**PLANNING COMMISSION
Meeting Agenda
Monday – October 28, 2013
7:00 PM**

MINOR PARTITION STAFF REPORT

FILE #: MLP 13-03

LOCATION: 658 NE 10th Ave

PROPOSED PLOT PLAN
 PARTITION- 658 NE 10TH ST.
 CITY OF CANBY, CLACKAMAS COUNTY

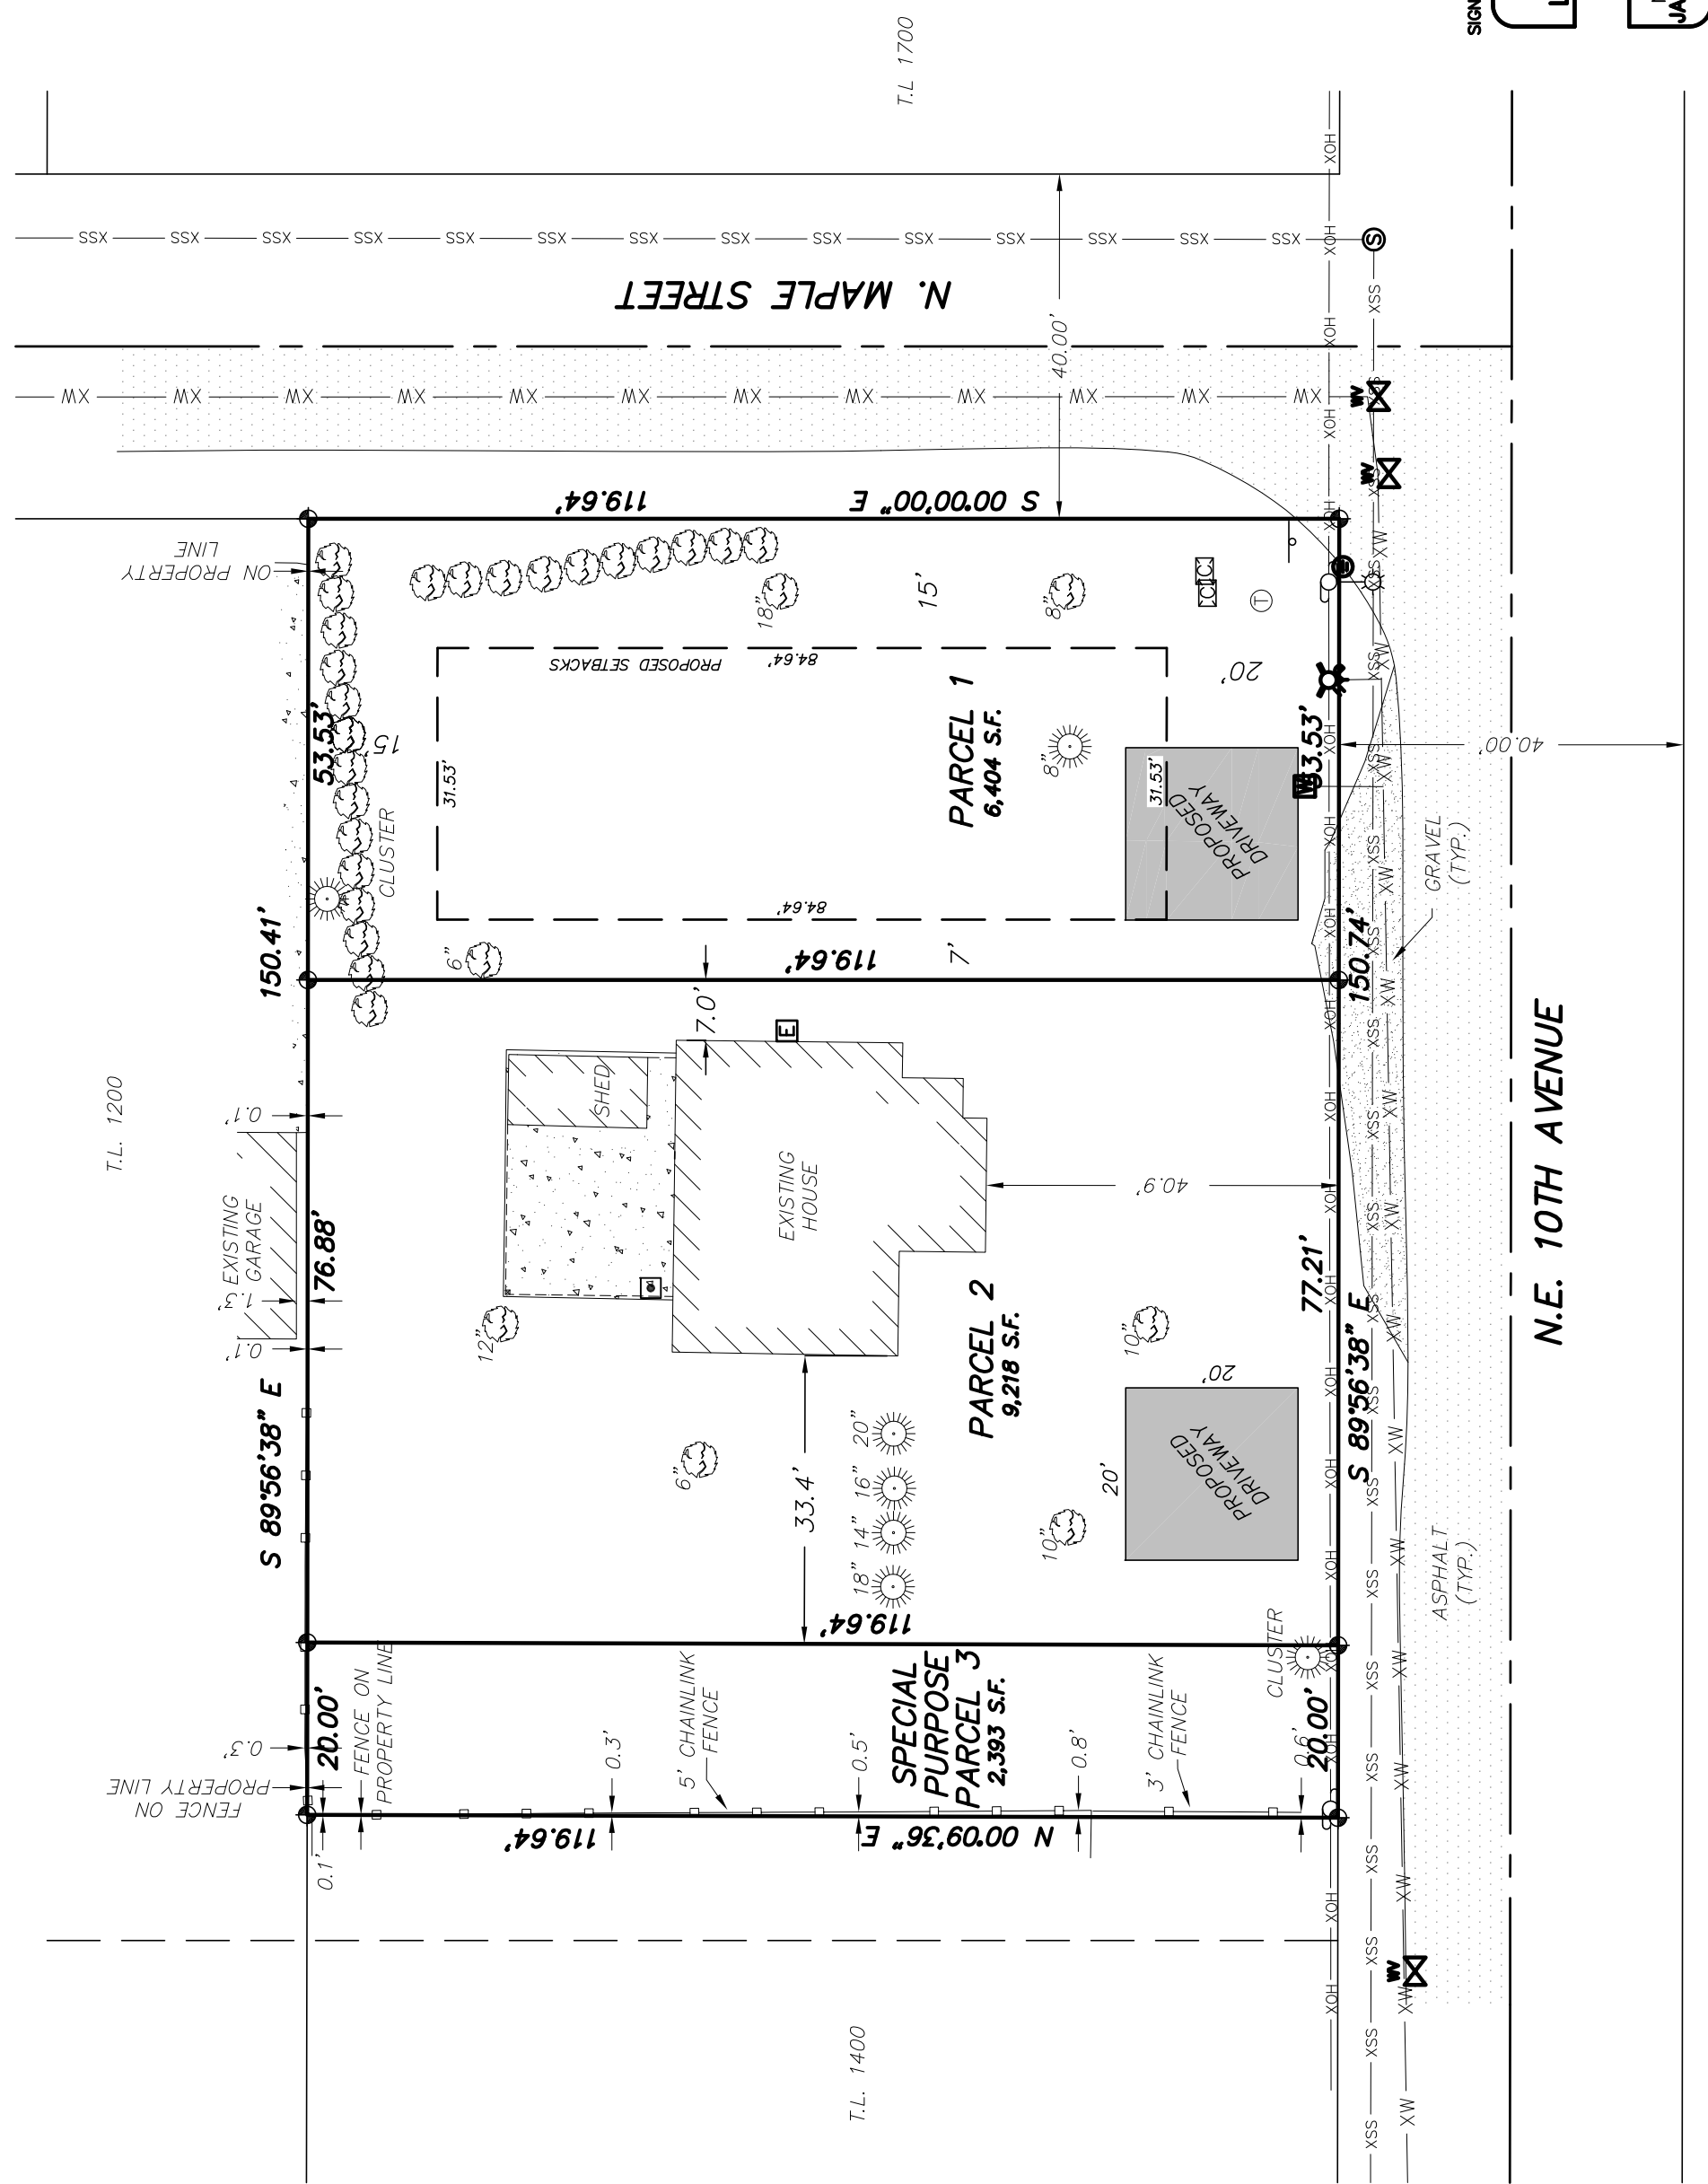
Findings: The applicant has indicated in the submitted narrative and at the pre-application conference that a 5 foot sidewalk and curb are proposed along Maple. The planned sidewalks along Maple are not shown on the proposed plat. As a **condition of approval**, the applicant shall submit engineered curb and sidewalk plans and install 5 foot sidewalks along the site's Maple frontage; the proposed plans shall be approved by the City Engineer and by Public Works prior to the issuance of a building permit. In addition, as a **condition of approval**, the applicant shall indicate a 5 foot sidewalk easement along Maple on the final partition plat. Finally, the City Engineer has requested that a 20' curb radius easement be dedicated at the corner of 10th and Maple for future sidewalk ADA ramp purposes; as a **condition of approval**, this 20' radius shall be noted on the final plat.

Findings: The applicant proposes Parcel 1 be 6,404 square feet; the applicant submitted two alternative lot line configurations, “Proposed Plot Plan Option 2” and “Proposed Plot Plan Option 3” to illustrate lot lines that meander around the existing house, which the applicant does not wish to demolish, in order to meet the minimum lot size of 7,000 square feet on Parcel 1. However, there are provisions in 16.64.040(E) that indicate that lot lines must be right

angles to the street the lot abuts, so a meandering line may not be the solution to obtaining the minimum lot size of 7,000 square feet. In addition, meandering lot lines are not recommended due to their impractical and illogical lot shapes they create. Therefore, the applicant requests that the Planning Commission permit Parcel 1 to be 6,404 square feet, 596 square feet below the minimum lot size.

Findings: The above standard is met if the Planning Commission approves “Proposed Plot Plan”; “Proposed Plot Plan Option 2” and “Proposed Plot Plan Option 3” would not meet the above standard.

2. The applicant shall show a 5 foot sidewalk easement along Maple Street on the final plat.

3. The applicant shall show a 5 foot sidewalk easement along 10th Avenue on the final plat.
4. A 20' sidewalk curb radius easement shall be noted on the final plat at the corner of 10th and Maple for future sidewalk ADA ramp construction purposes.
